AMERICAN HONDA MOTOR CO., INC.
ANN ARBOR LABORATORY • 3947 RESEARCH PARK DRIVE
ANN ARBOR, MICHIGAN 48108 • (734) 994-8441 (734) 665-5998

American Honda Motor Company, Inc. (Honda) appreciates the opportunity to provide comments on CARB's Second Notice of Public Availability of Modified Text regarding Plug-In Hybrid Electric Vehicle Test Procedure Amendments published on November 2, 2009.

2. Urban Charge Depleting Range Test

6. R_{cda} in Transition Cycle (transition between CD and CS modes)

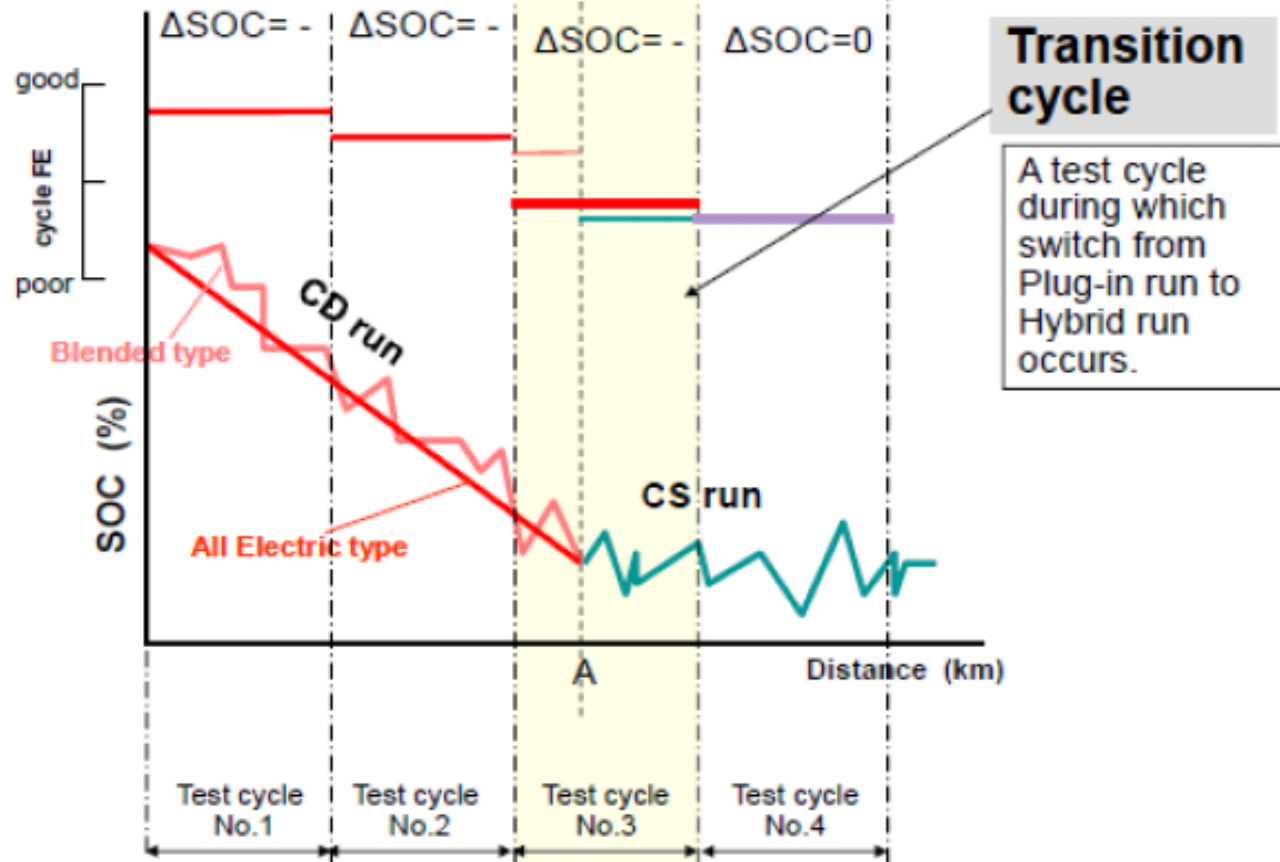
| | 2nd 15-Day Notice |
|---------------------------|---|
| Honda comment | <p>Concern with CARB Section F.11.9: R_{cda} variability may be too big, as it depends on the variability of the state-of-charge in the subsequent charge sustaining cycles.</p> <p>For R_{cda} determination, Honda recommends adoption of technical standard method in Japan for Transition Cycle Charge Depleting Range. This is a mathematical method using CO₂ emissions ratio in the Transitional Cycle to refine the accuracy of the resulting R_{cda} range.</p> <p>This proposal is also been considered by the SAE J1711 Working Group members.</p> <p>Please refer to following pages for explanation of the technical standard method in Japan.</p> |
